APPLICATION RESPONSE

Comments following submission of planning application HGY/2023/1208 to upgrade of a current make shift BMX trail into permanent trail for children of all ages:

The land adjacent to 1 Shepherds Hill, London, N6 5QJ

Shepherds Hill BMX Trail - Application Comments

7.4 Photos showing Graffiti usually associated with BMX Track and Skate Park:

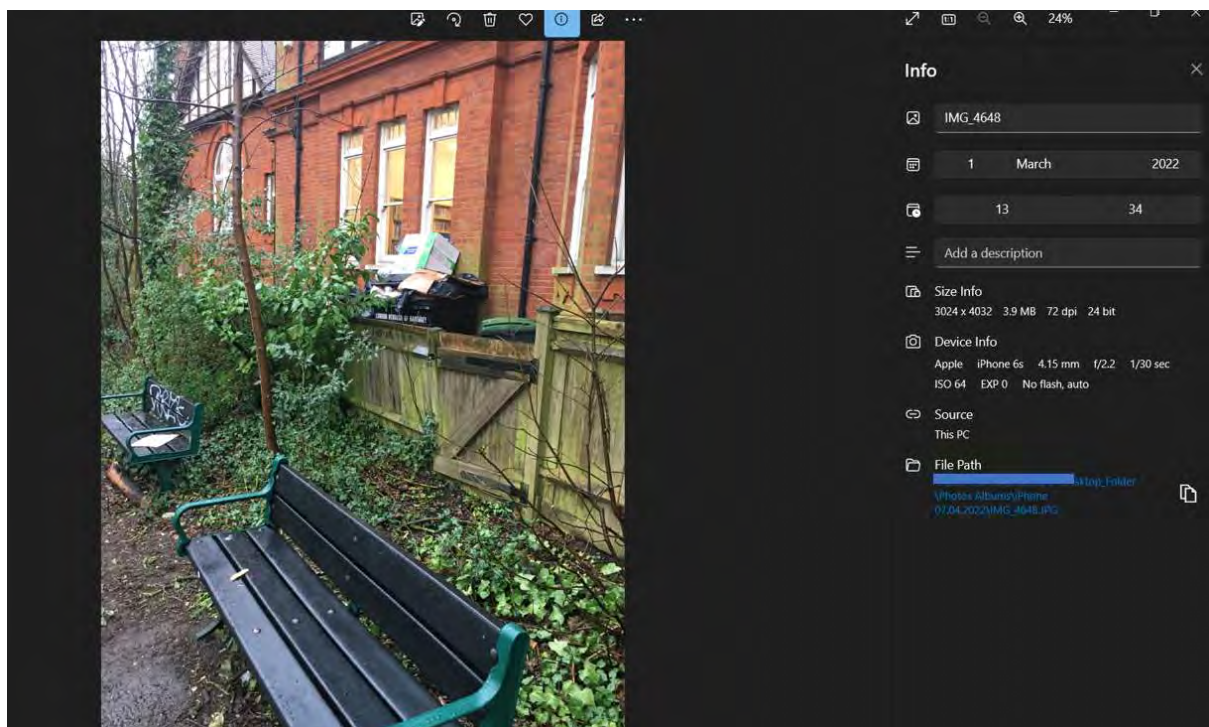
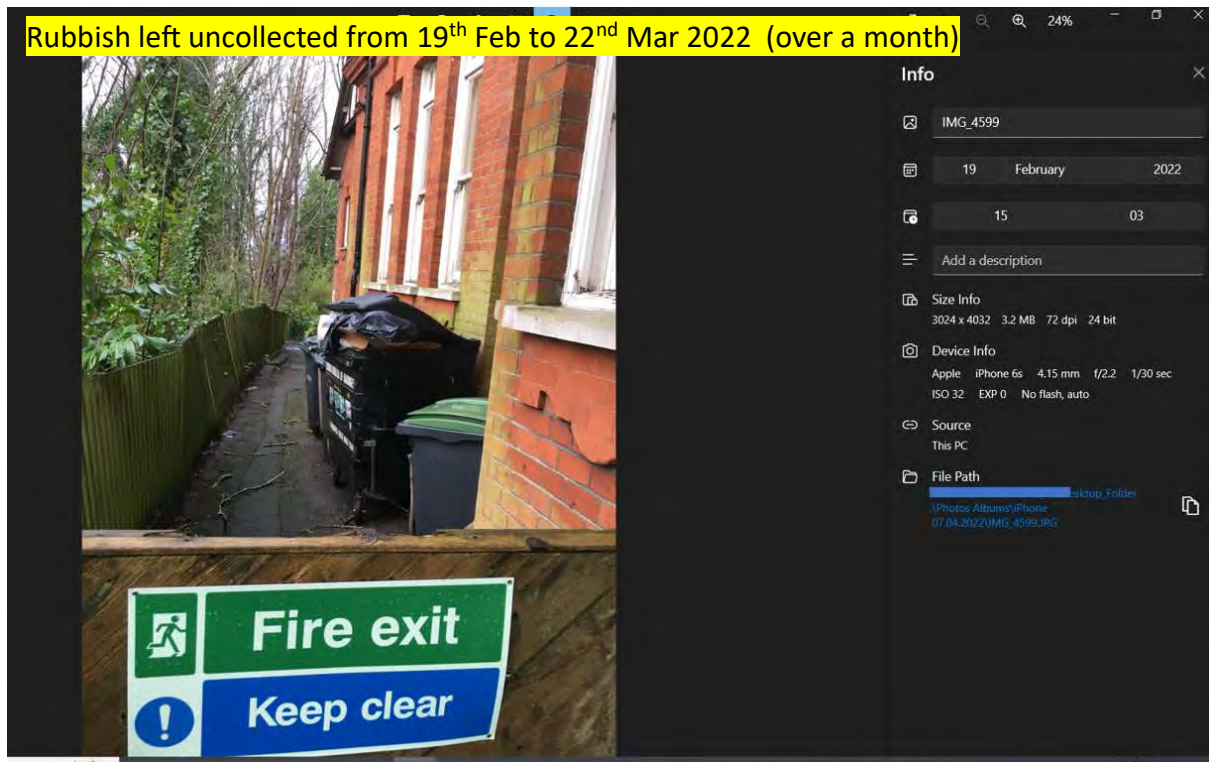
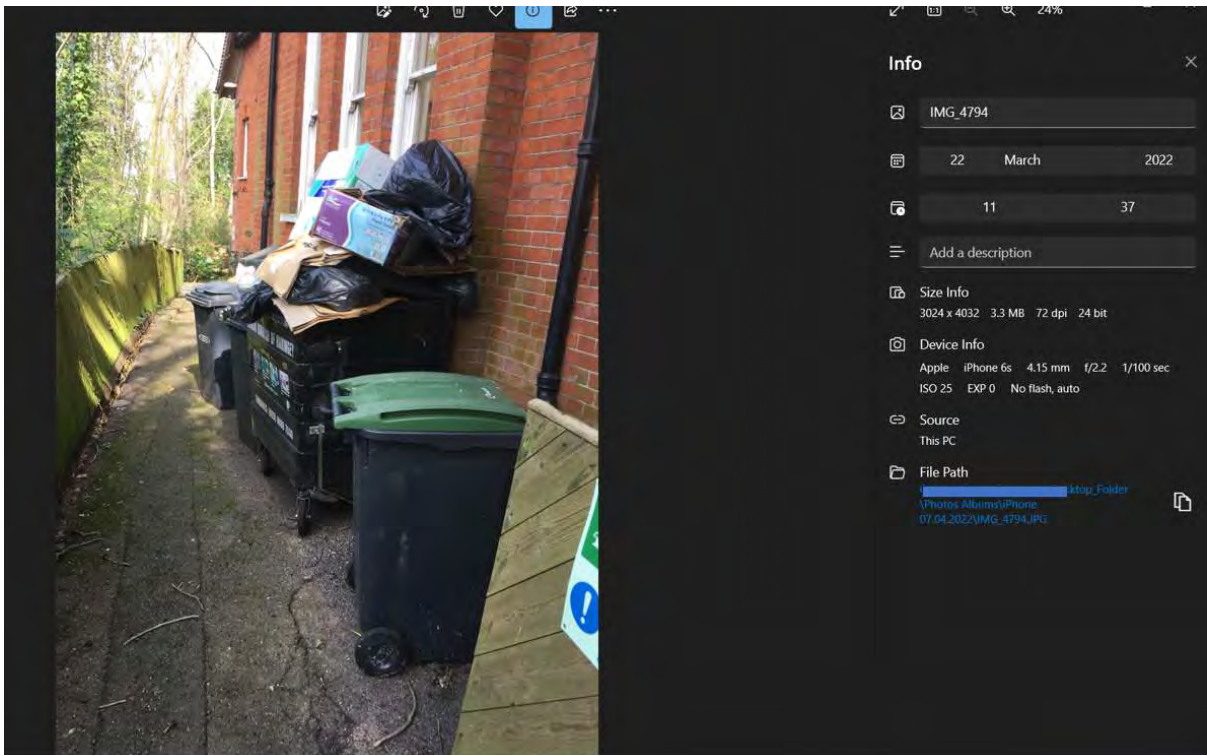
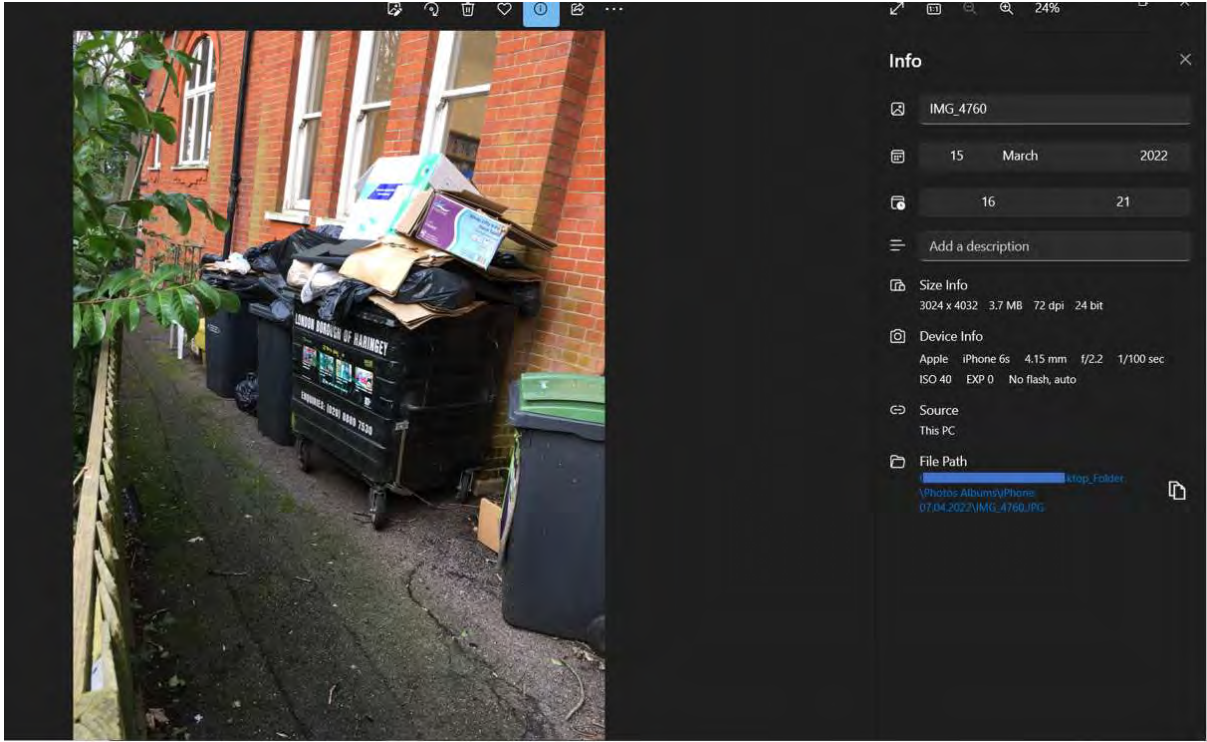
Over the last 20 years or so, the neighbourhood has been affected by anti-social behaviour largely resulting from the gathering at the site of young and middle-aged men for illicit drug taking/dealing and public alcohol consumption. Littering, loitering, intimidation, mugging/phone-snatching, graffiti and other damage to public and private properties are very common. *(Please refer to photos in Section 7.4 and see how culture of graffiti intertwined with hi-octane activities such as skateboarding and BMX bike as evidenced at Lordship Lane, SE22 (illegal occupancy of former Grove Pub) and Stockwell Road, Brixton, SW9)*

7.5 Photos of accumulated uncollected Rubbish at the Library & Other ASBs in general:

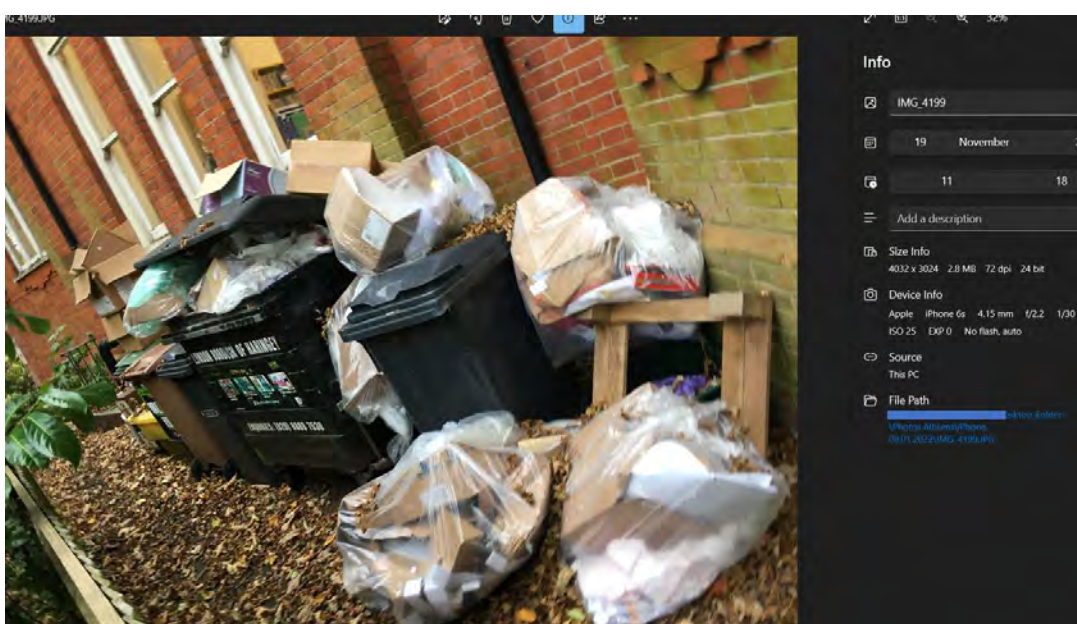
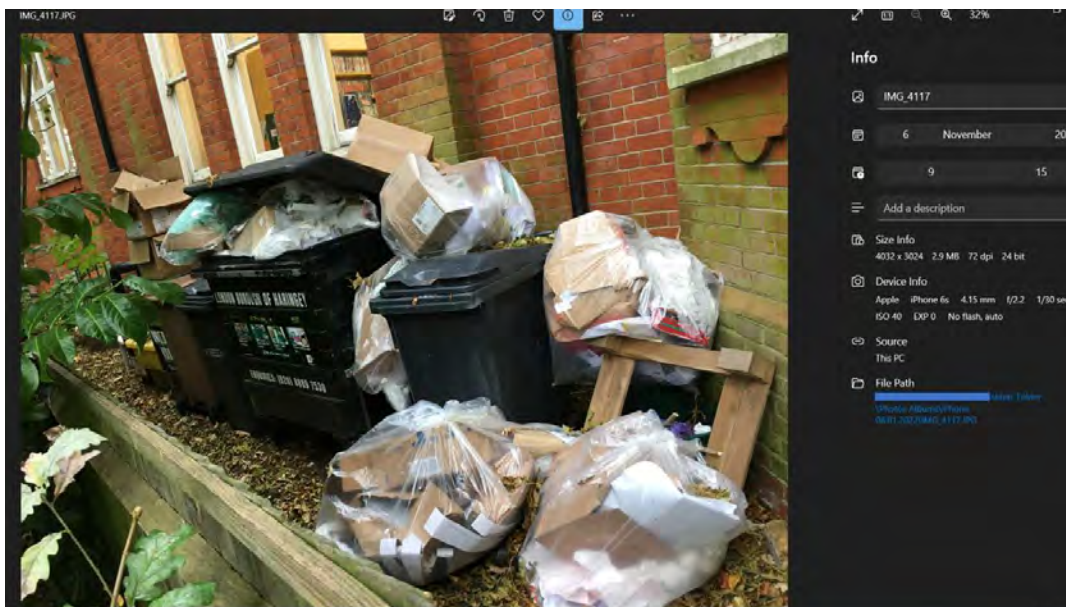
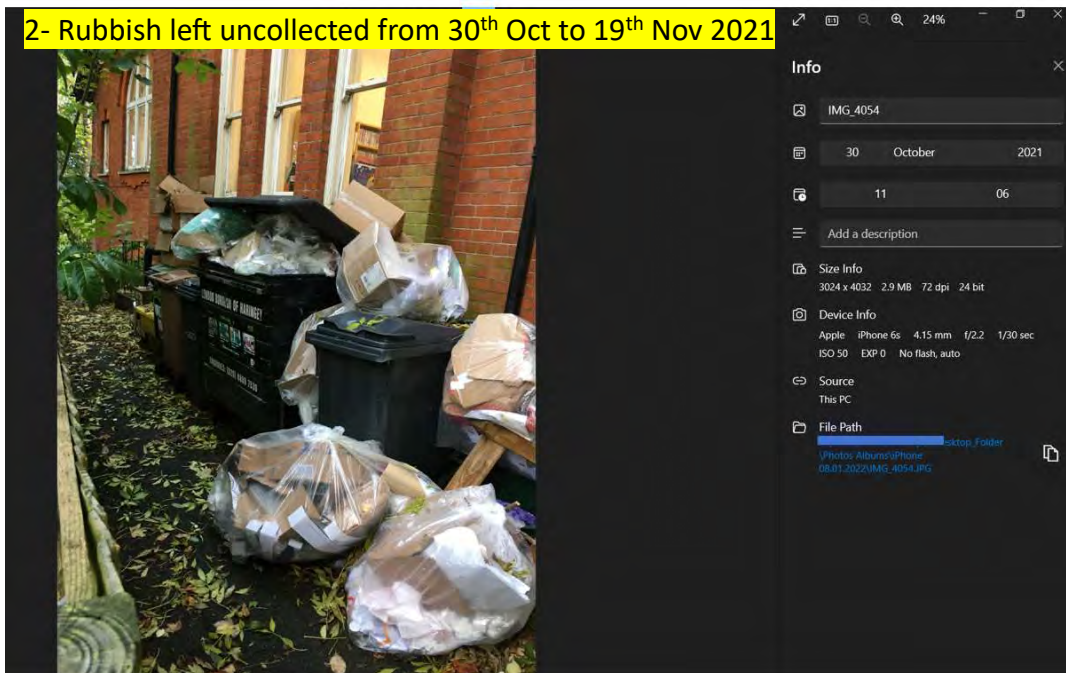
Application states that there will an on-going maintenance plan is to be included and the track will be put on the council's rota to be looked after. There is no clear statement from the Haringey that they will take full responsibility of the maintenance and NOT to rely on volunteers. Someone or entity should take responsibility. Even with full responsibility of the

Council, things would not have happened as they should be. Examples are uncollected accumulated rubbish on the ground of Library. *(Please refer to photos in Section 7.5)*
